ENGAGEMENT OUTCOMES REPORT

COMMUNITY AND BIKE USER
GROUP (CBUG)

TRANSPORT FOR
NSW

Date
14/07/2022 v2.0

Arial view
of
proposed
design

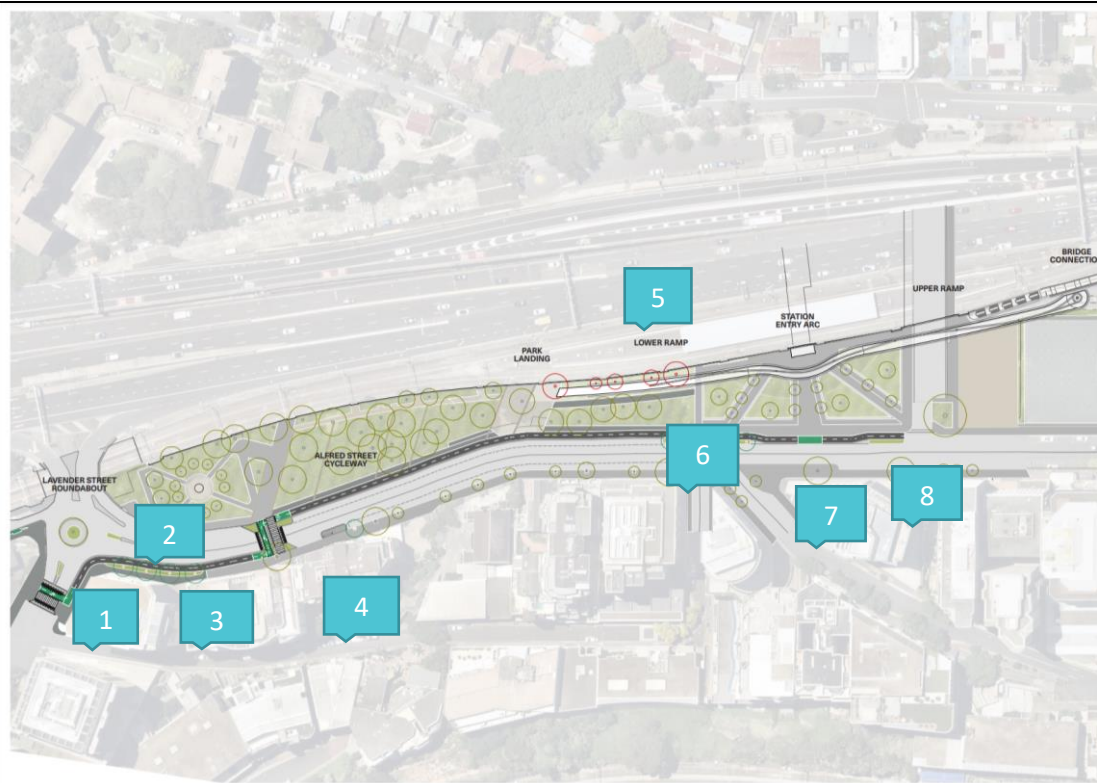
1) Crossing location for safety and convenience

2) Suggestion: Road space instead of trees.

3) Currently a dark overshadowed location. Use low level trees.

4) Install barrier to stop cars from overtaking buses and risking the safety of pedestrians

5) Plant climbing fauna on columns

6) Design the area underneath the ramp for homeless people.

7) Uber pick up and drop off at bus bay

8) is there an opportunity to keep the shared path?

100 Alfred St – Comments

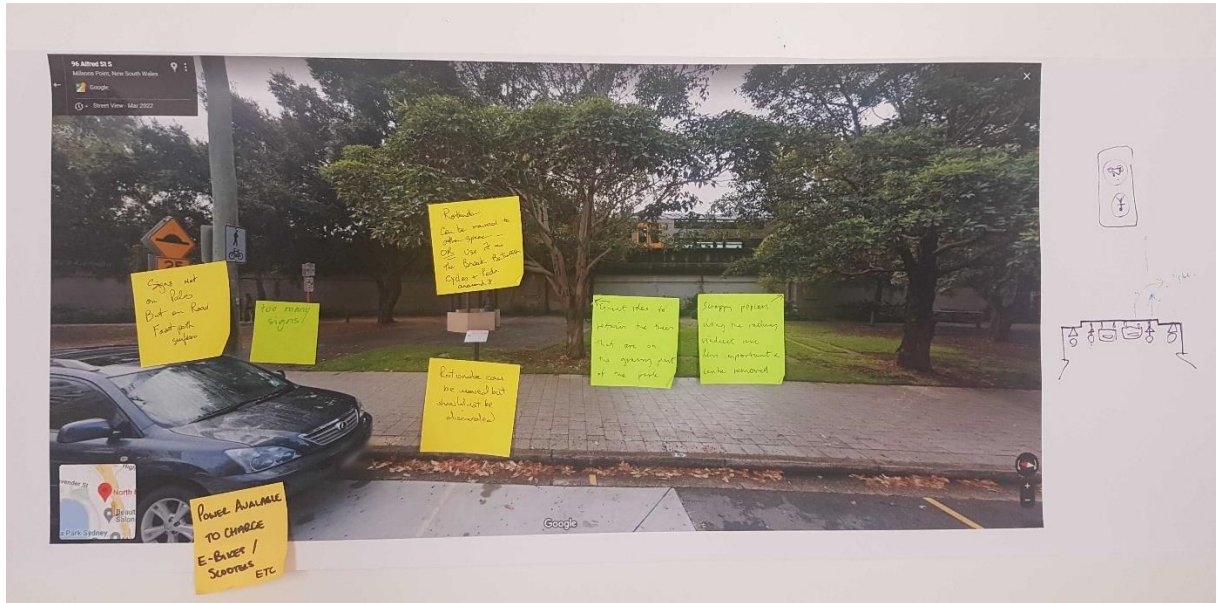
- 1) Please do thorough traffic study of Alfred St. Including buses, school buses, out of service buses, before narrowing road width. This is one of the two access points for Kirribilli peninsula – High St + Clark Rd the other. Please don't stuff up both for the local residents. High St is going to be stuffed-up by WHT + BL access from High St
- 2) What is the current width of road? Lane – should not be narrowed!
- 3) Bike path colours to blend in with environment

96 Alfred St – Comments

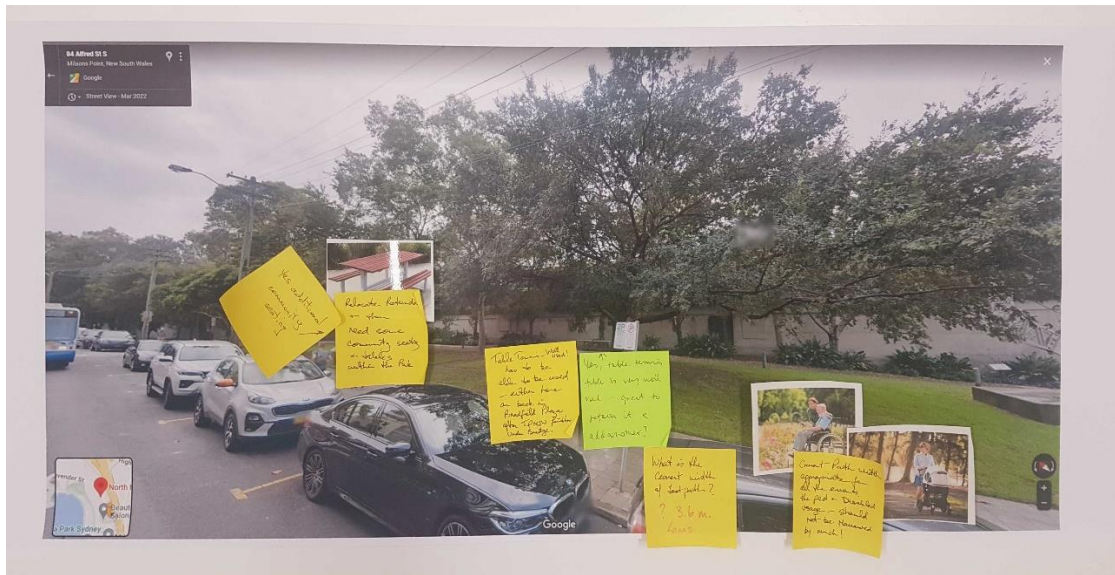
- 1) Signs not on poles but on road & footpath surfaces
- 2) Too many signs
- 3) Power available to charge e-bikes/scooters/etc
- 4) Rotunda can be moved to other space – OR use it as the break between cyclists + pedestrians around it
- 5) Rotunda can be moved but should not be discarded
- 6) Great idea to retain the trees that are on the grassy part of the park
- 7) Scraggy poplars along the railway viaduct are less important & can be removed

84 Alfred St - Comments

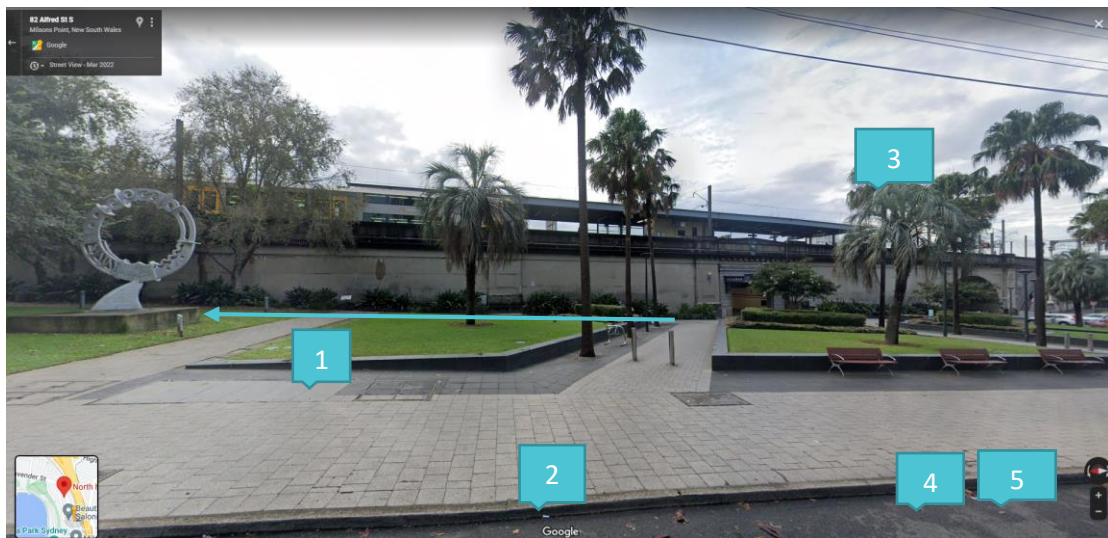
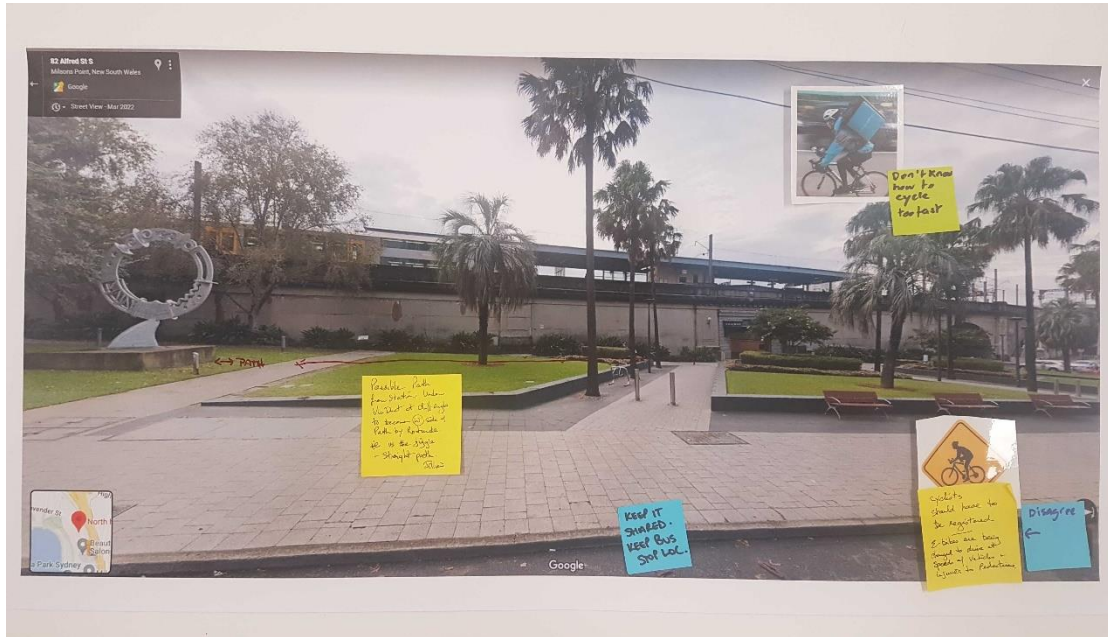
- 1) Yes additional community seating
- 2) Relocate rotunda + then need some community seats & tables within the park
- 3) Table tennis – well used! Has to be able to be used – either here or back in Bradfield Plaza after TfNSW finishes under bridge
- 4) Yes, table tennis table is very well used – great to retain it & add another?
- 5) What is the current width of footpath? (? 3.6m. Lewis.)
- 6) Current path width appropriate for all the events, the pedestrian + disabled usage – should not be narrowed by much!

82 Alfred St - Comments

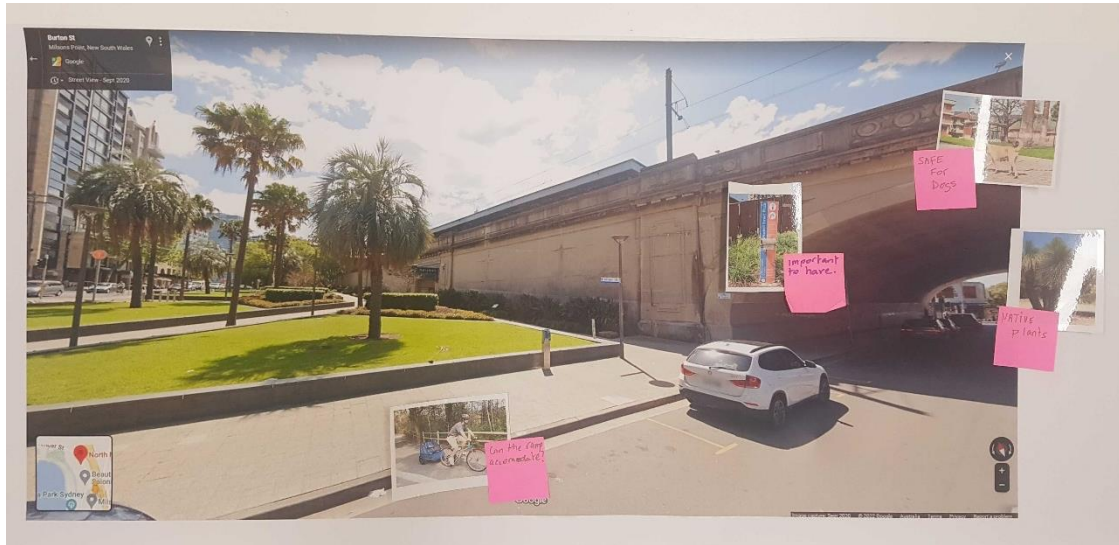
- 1) Consider use of plants native to Australia
- 2) Positive to underground the wires + electricity
- 3) Cyclist should dismount in High Rd area
- 4) Too many signs
- 5) Use pavers that blend in with surrounds, not bright paint
- 6) Bus stop to stay. Shared bike path south
- 7) Retain bus stops outside Milson Point Station – very convenient location for commuters – doesn't impact cyclists too much, especially once the ramp is built. Retain existing shared path.
- 8) This bay is used for parking pick ups & drop offs for uber, taxis, friends, etc
- 9) Buses need to stay here for (?) access off road when no TRAINS running
- 10) This location of bus stop has lots of space & doesn't interfere with traffic.
Moving it down the street creates the exact opposite.
- 11) Remove the tent
- 12) Benches ok but well located

Middlemiss St - Comments

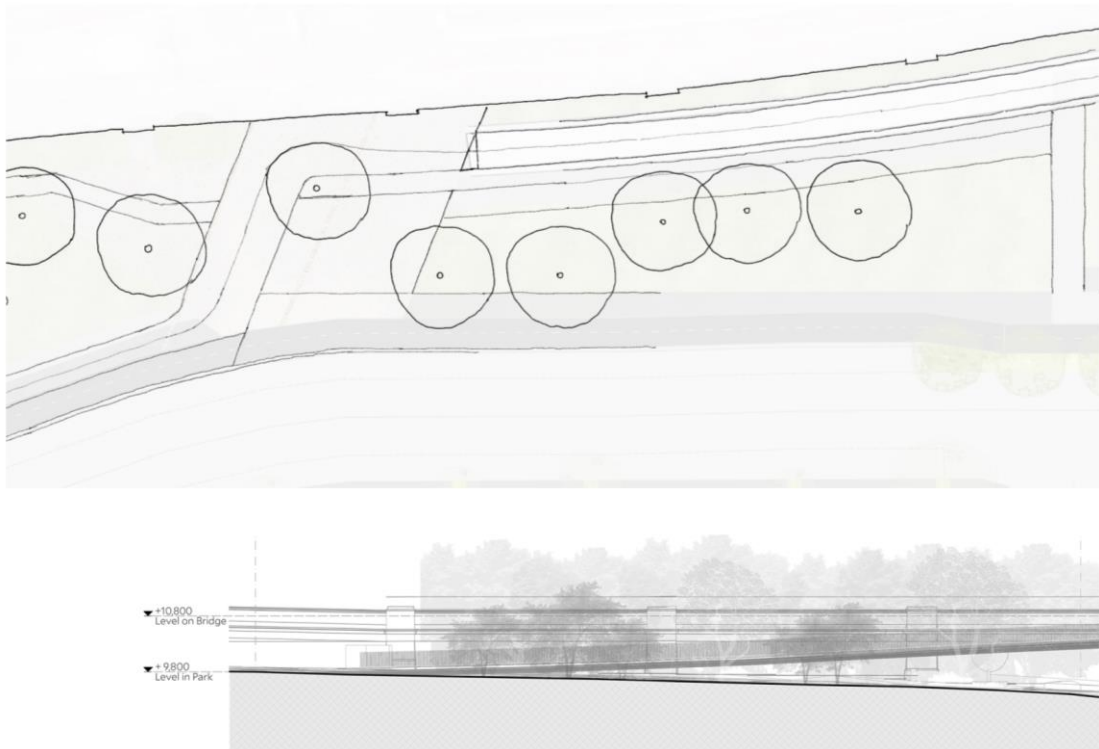
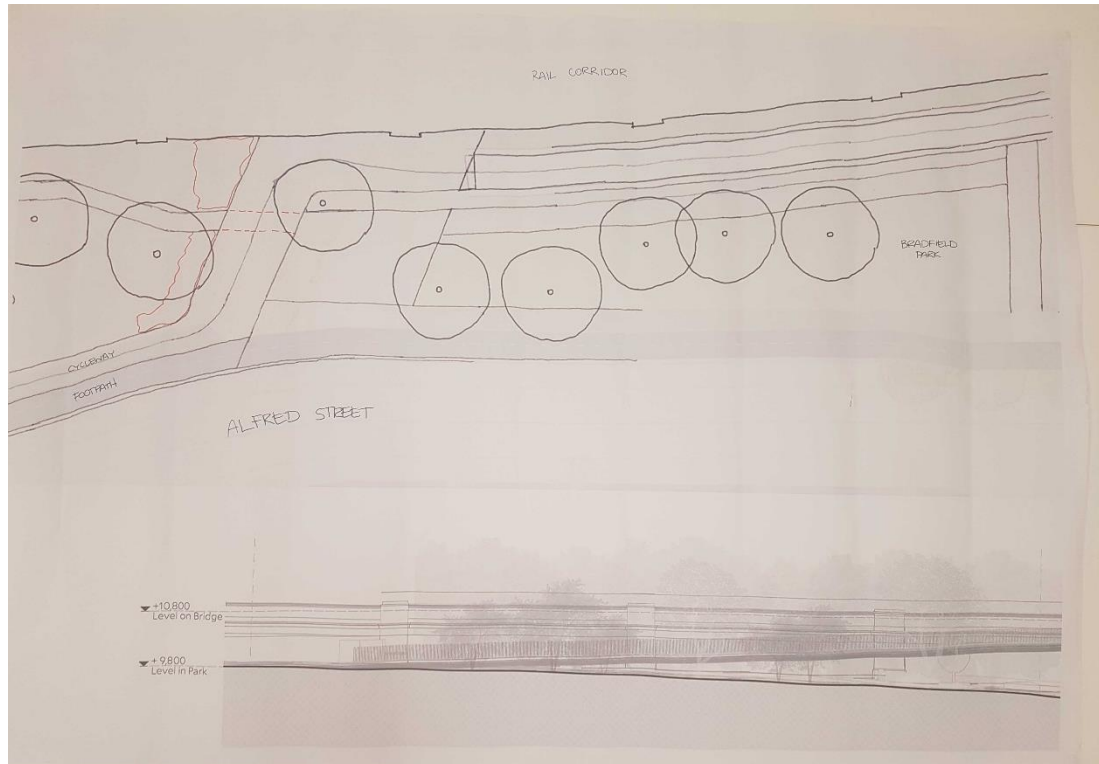
- 1) This small slipway into Middlemiss St is really useful and should be retained

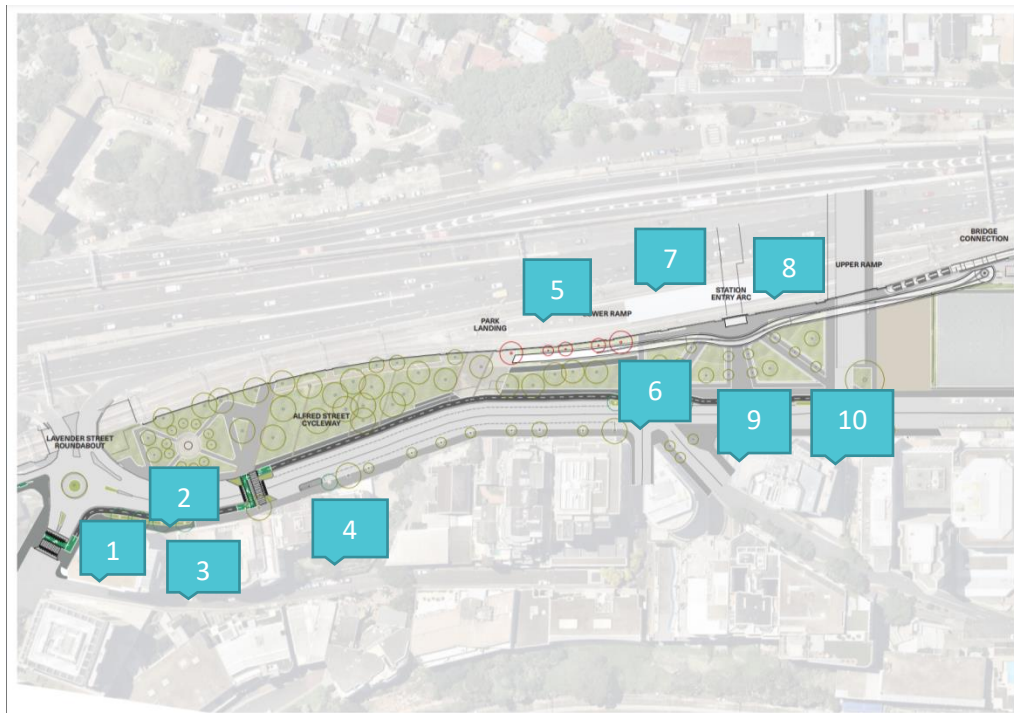
- 1) Need to slow cyclists down
- 2) Reduce cyclist speed on ramp slope
- 3) Yes to underground wires
- 4) Keep tree cover in main grassy area – don't need to retain poplars along viaduct
- 5) Planting/climbers on columns

- 1) Crossing location; safety, convenience
- 2) Road space instead of trees maybe
- 3) Dark over-shadowed place – use lob level trees
- 4) Barrier to stop cars overtaking buses + risking safety of pedestrians
- 5) Design the bit under the ramp for homeless people
- 6) Diagonal walking path under ramp
- 7) ← Flow pedestrians →
- 8) Throwscreen NO!

- 9) Uber pickup/drop-off at bus bay
- 10) Opportunity to keep shared path?
